Form 3160-5 (June 2015)

BC OPERATING, INC. RESPECTFULLY REQUESTS TO:

KYLE 34 FEDERAL COM #5H 30-015-43295 EDDY COUNTY, NM

WORK INFO

System Drawing

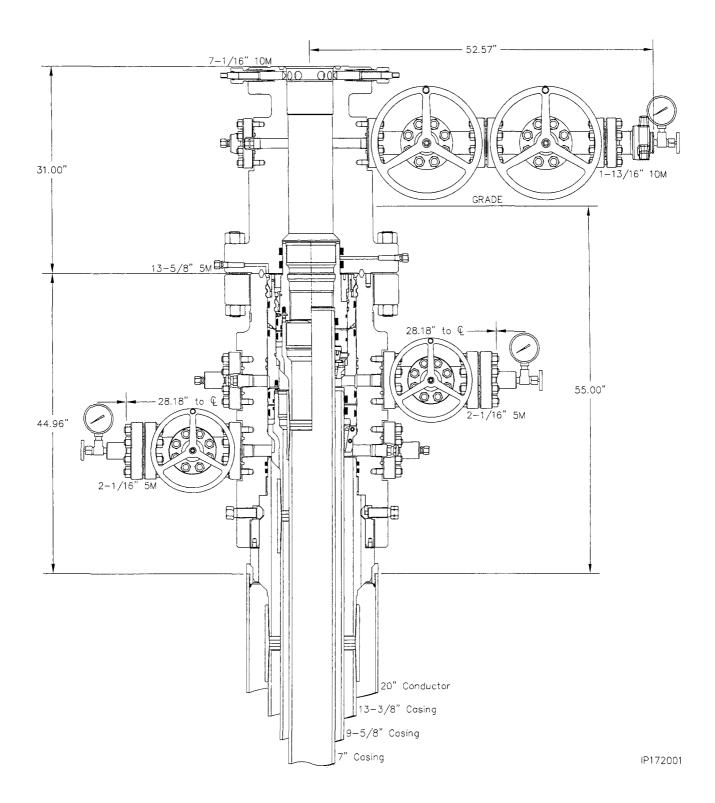
- Displace to 11.5 ppg INTEGRADE OBM.
- Drill 6.125" production interval
- Monitor volumes, gas, and cuttings at shakers for formation indications
- Maintain mud properties as per program
- Set 4.5" Production Liner
- (4) Multibowl procedure is attached for reference and will be included in the electronic filing. We will test in accordance with COAs and BLM onshore order 2 if seals are broken.

Operator has proposed a multi-bowl wellhead assembly. This assembly will only be tested when installed on the surface casing. Minimum working pressure of the blowout preventer (BOP) and related equipment (BOPE) required for drilling below the surface casing shoe shall be 5000 (5M) psi.

- a. Wellhead shall be installed by manufacturer's representatives, submit documentation with subsequent sundry.
- b. If the welding is performed by a third party, the manufacturer's representative shall monitor the temperature to verify that it does not exceed the maximum temperature of the seal.
- c. Manufacturer representative shall install the test plug for the initial BOP test.
- d. Operator shall perform the intermediate casing integrity test to 70% of the casing burst. This will test the multi-bowl seals.
- e. If the cement does not circulate and one inch operations would have been possible with a standard wellhead, the well head shall be cut off, cementing operations performed and another wellhead installed.
